Sawmills

ADA Transition Plan

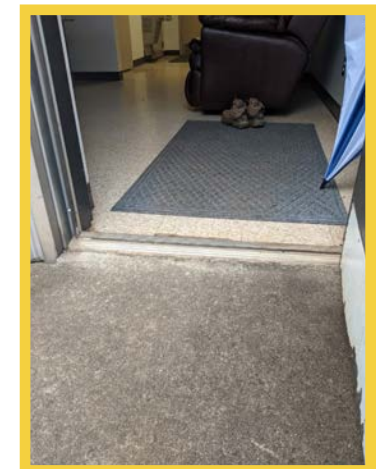
Threshold coming in at the exterior door could become a trip hazard.

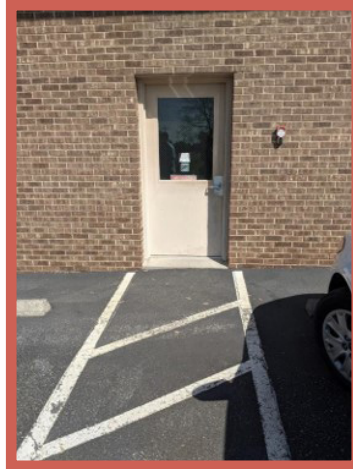
There are currently steps throughout Town Hall and no accessible route around them.

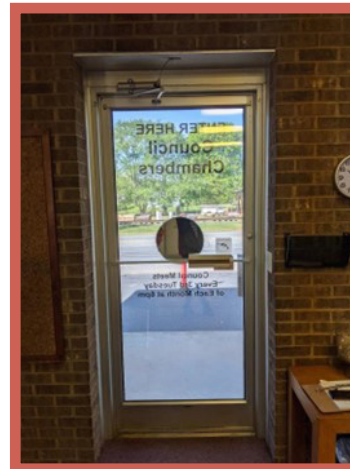
The back employee entrance may be a temporary option as an accessible route

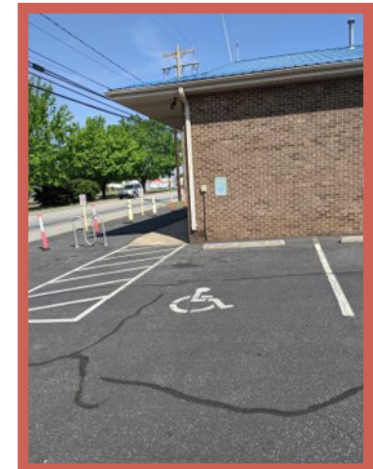
Several doorways throughout Town Hall were too narrow.

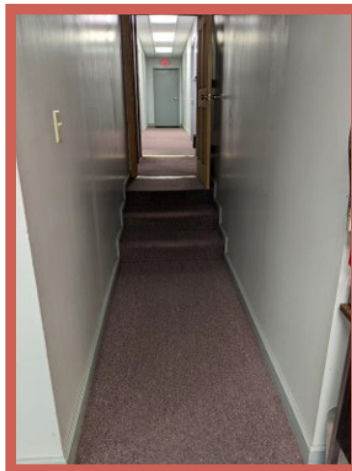
There is no accessible way to access the restroom

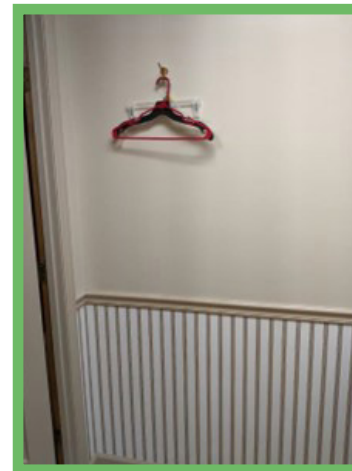
Accessible restroom signage should be placed on the latch side of the doorway.

Lower coat hanger.

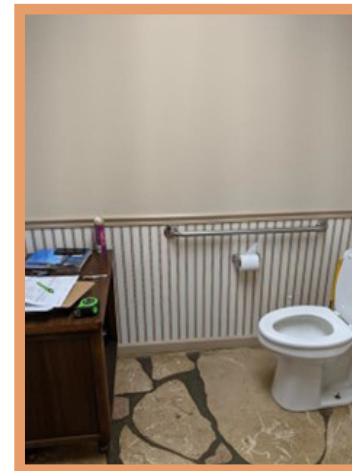
Currently not enough maneuverable space.

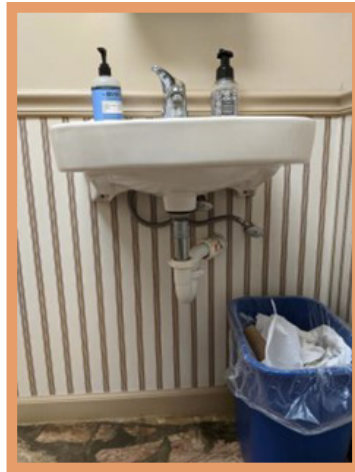
Lower mirror.

Fully insulate pipes.

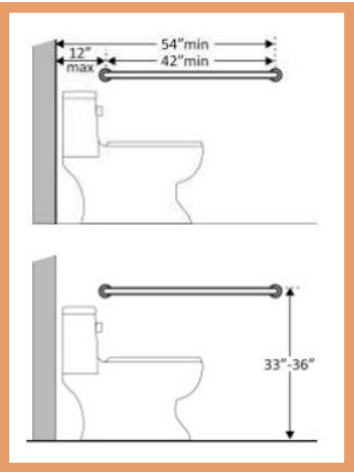
Side bar grab needs to meet designated requirements.

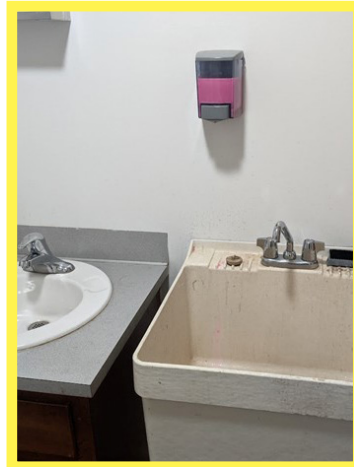
Signage should be in braille and mounted on latch side of door

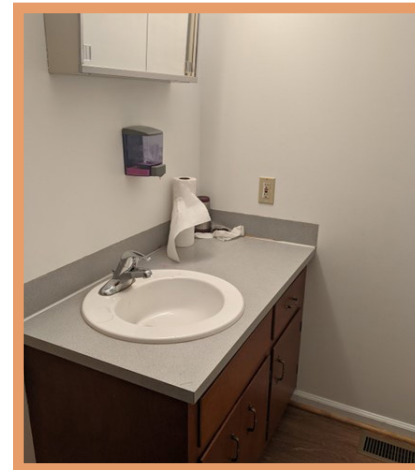
There is currently not enough clearance around the toilet

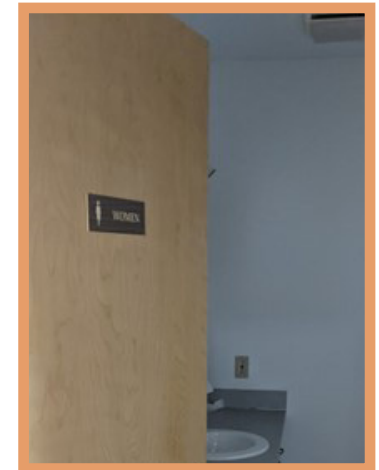
There is not enough knee space under the sink

Signage should be in braille and mounted on latch side of door

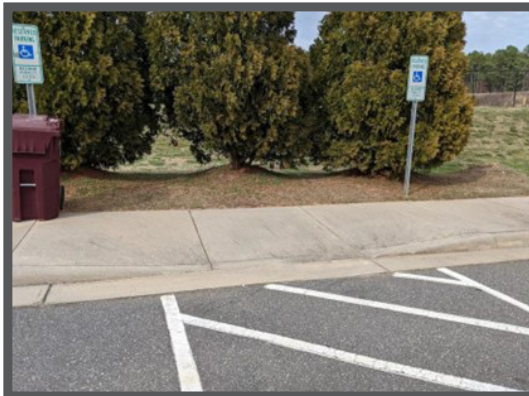
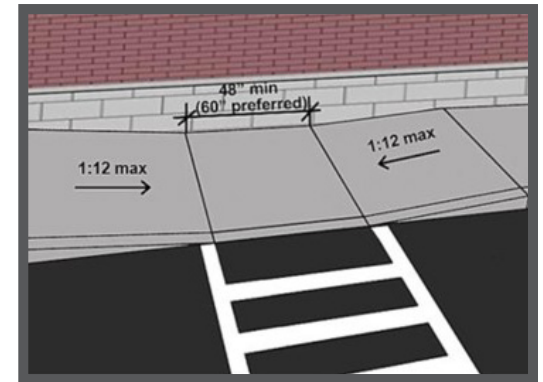
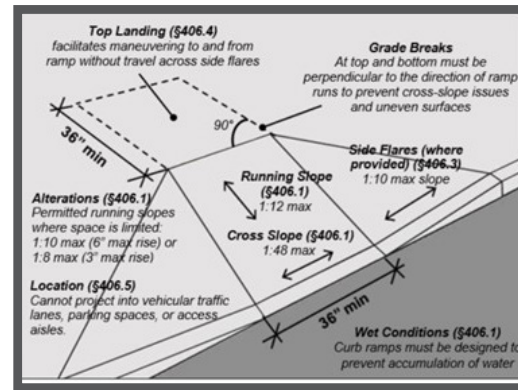
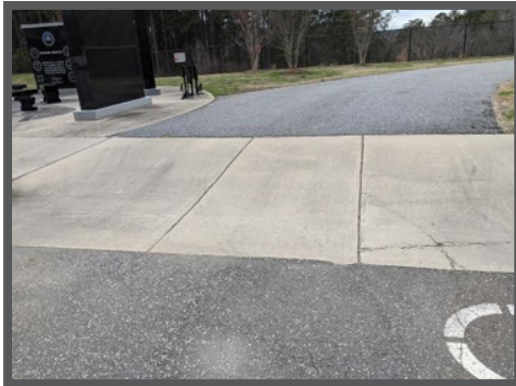
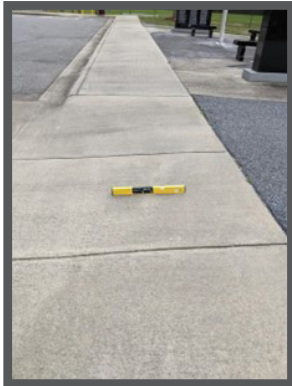
- » Driveway cuts that cross pedestrian routes must have a 2% or less cross slope.
- » The curb ramps at the accessible spaces (closest to the restrooms) have no level landing and creates a 5% cross slope for pedestrians using the sidewalk. Example curb ramp types are shown below. The first example shows a top landing that prevents pedestrian hazards when crossed. The second example shows parallel curb ramps used for confined spaces. The limited slope and flat landing prevents pedestrian hazards.

The curb ramp closest to the soccer field has a top landing right next to the stairs. Recommend high-viz striped tape on the stairs as well as directional signage showing the nearest accessible route. (high recommendation)

Lower Veteran's Park

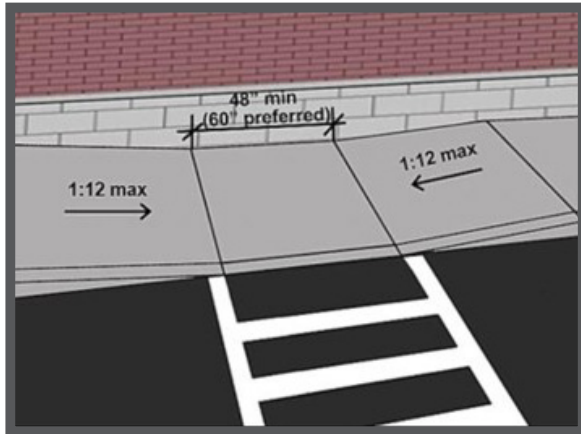
- » The curb ramps at the accessible parking spaces do not follow ADA measurements. The current curb ramps create an unsafe cross slope for all pedestrians. Please see the example below of a parallel curb ramp. The parallel curb ramp is the best fit for the space.

Parking at Lower Veteran's Park

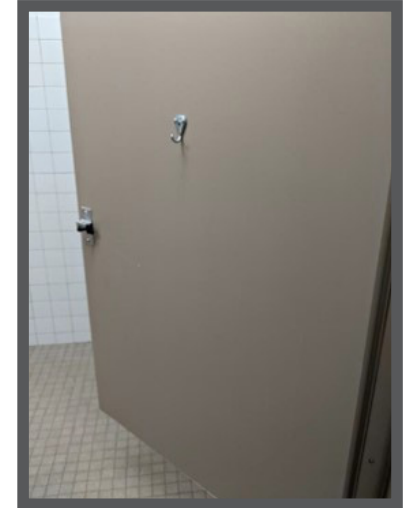
The 6th accessible space (far right) is not signed. Accessible signage must be posted 60" from the ground to the bottom of the sign.

Playground

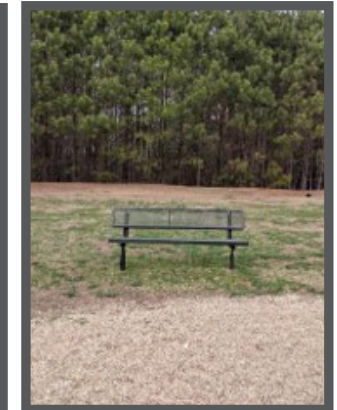
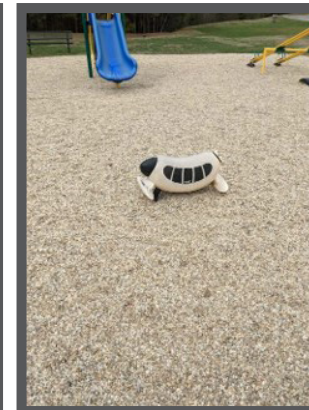
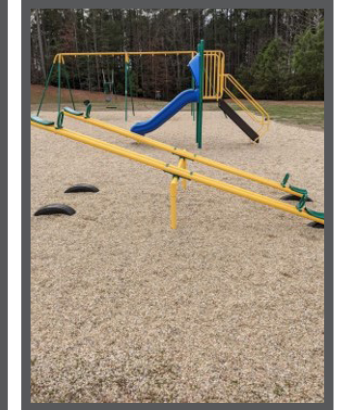
- » The current gravel surface in the playground is not ADA compliant.
 - » Appendix C.1 covers some of the stipulations for ADA playground and accessible route surfaces.
 - » Appendix C.2 covers multiple ground surfaces to consider in both play grounds and accessible paths.
 - » There must be an ADA accessible route to one of each park element. One bench, gazebo, seesaw, slide, bouncer, and swing must connect to the entry/exit of the park. The entry and exit of the park must also connect to the parking area via accessible route. This is the only way persons in wheelchairs (guardians or children) can safely access these elements.

- » Recommendation: There are currently no ADA Standards regulating disc golf. It is, however, recommended that a small portion of holes are accessible to all by means of accessible routes. Accessible routes are continuous, unobstructed paths connecting all accessible elements.
- » Recommendation: Accessible playground equipment is recommended for this park. Currently, there is no inclusive playground equipment.

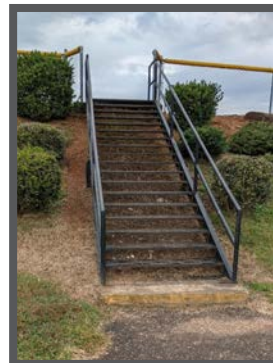
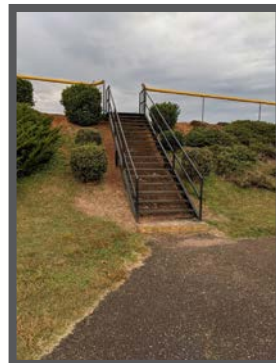
- » Add directional signage at staircases noting where accessible pathways can be found.
- » There is a vertical discontinuity that could be a trip hazard at the top of the staircase. The asphalt should be beveled to correct.

- » Recommendation: Include yellow reflective tape on steep staircases.

Women's Restroom

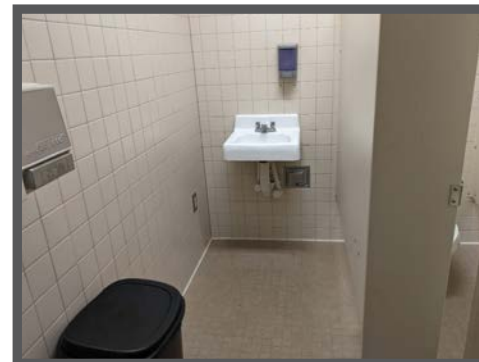
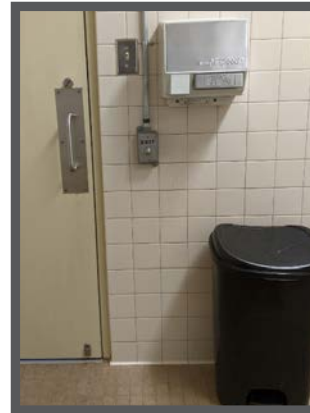
- » The operable parts of the light switch can be no higher than 48" above the floor. Currently, the light switch is mounted 50" above the floor. *If constructed before 3/15/2012 and a parallel approach is provided, controls can be 54" above the floor.*

- » ADA Standards require restroom signs to contrast with their background. The current sign is placed correctly, however, is faded and cannot be seen by all users.

- » Shift the trash can to make a 36" wide accessible pathway to the sink and the hand dryer. Currently, both are obstructed due to the trash can location.

Men's Restroom

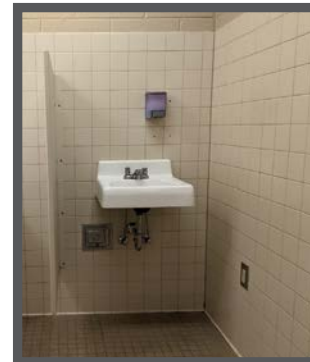
- » The operable parts of the light switch can be no higher than 48" above the floor. Currently, the light switch is mounted 50" above the floor. *If constructed before 3/15/2012 and a parallel approach is provided, controls can be 54" above the floor.*

- » ADA Standards require restroom signs to contrast with their background. The current sign is placed correctly, however, is faded and cannot be seen by all users.

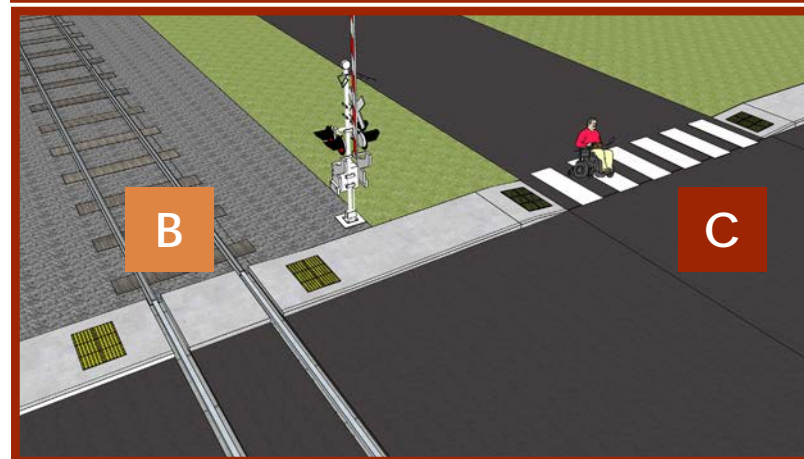
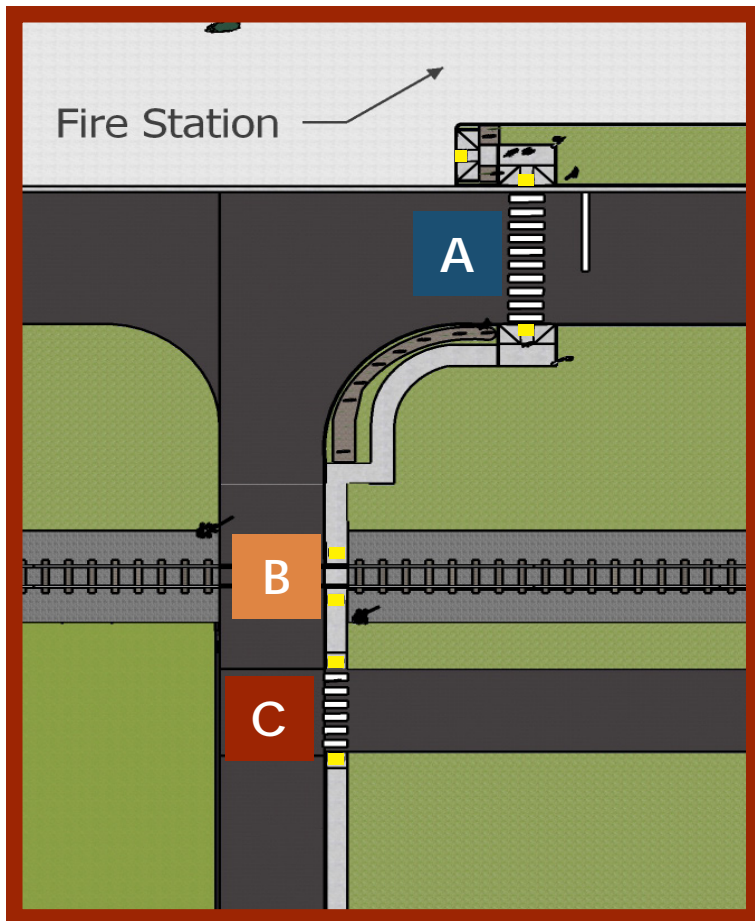
- » Sidewalk and curb ramps along Helena St connecting to existing sidewalk on Sawmills School Rd.
- » Option 2: Connect sidewalk from Helena St directly to paved area under pavilion.

- » Curb ramps are needed on both sides of Sawmills School Rd at the intersection of Helena St.
- » Detectable warnings are required for curb ramps leading pedestrians into roadways.

Sawmills Elementary School Entrance

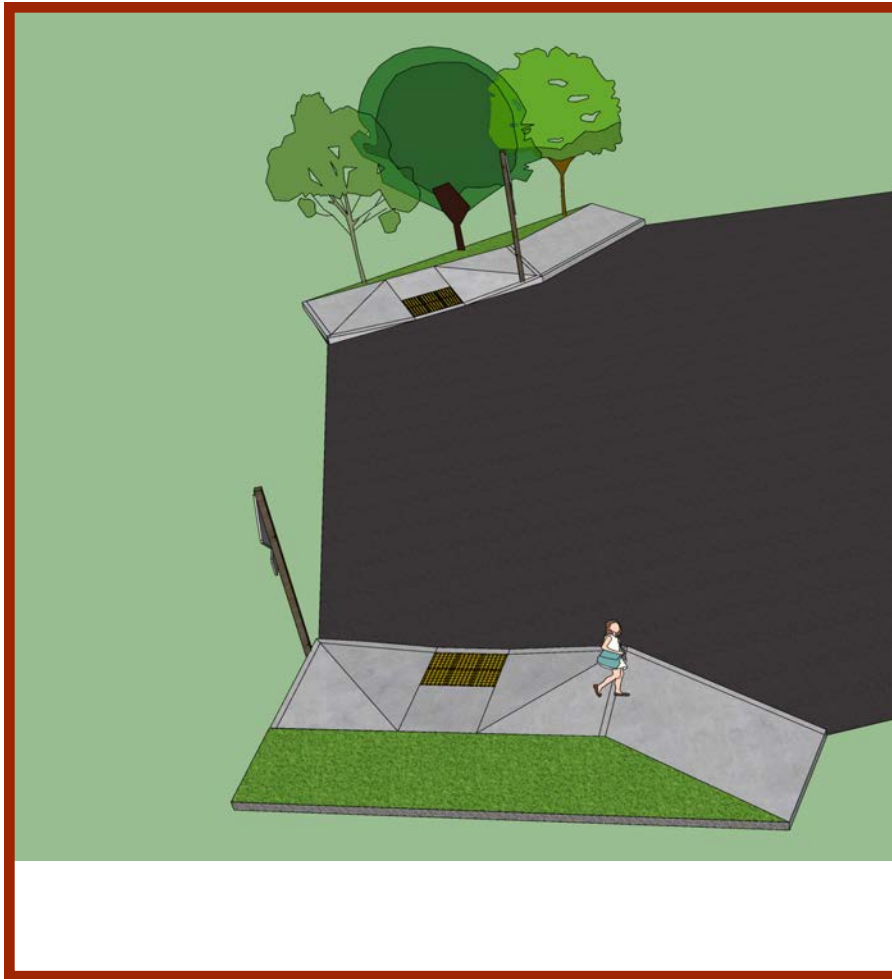
- A » High visual crosswalk with compliant curb ramps, detectable warnings, and pedestrian signage are needed at both ends of crosswalk.
